FIELD OBSERVATION REPORT

Project: Sebago Heights Subdivision – Phase 3&4

Visit Date: October 24, 2016

Photo 5 – Area of sparse vegetation at edge of pavement near +/- 21+00 RT.

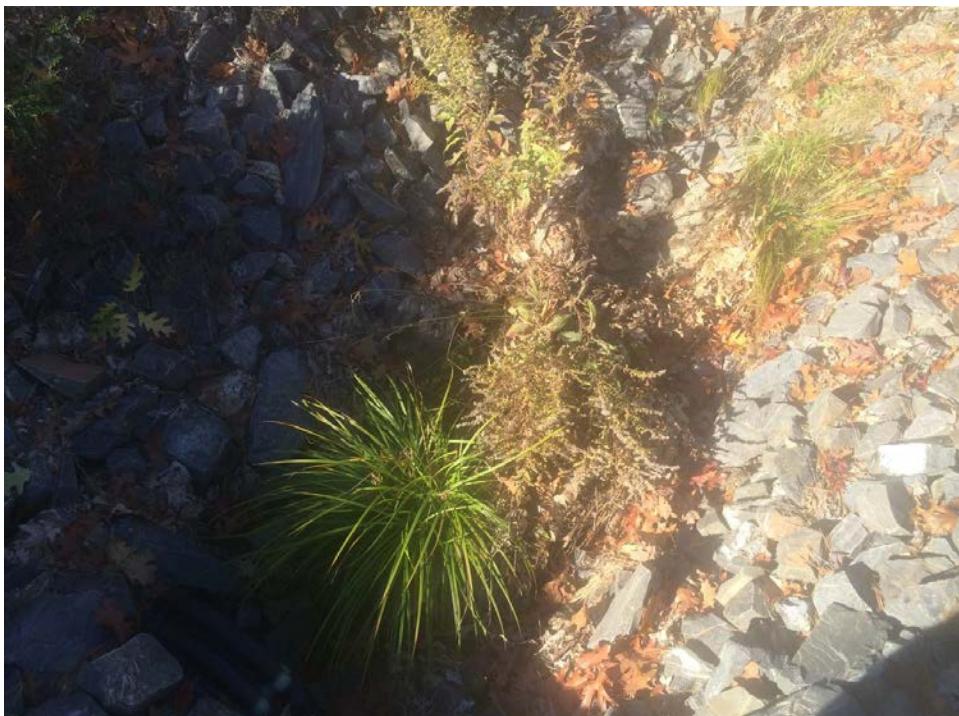
- Sediment in riprap apron for CB21 outlet. Sediment shall be removed from the riprap apron.
- Vegetation is sparse at the edge of pavement from +/- sta. 17+00 to 21+00 RT. Area shall be re-seeded.
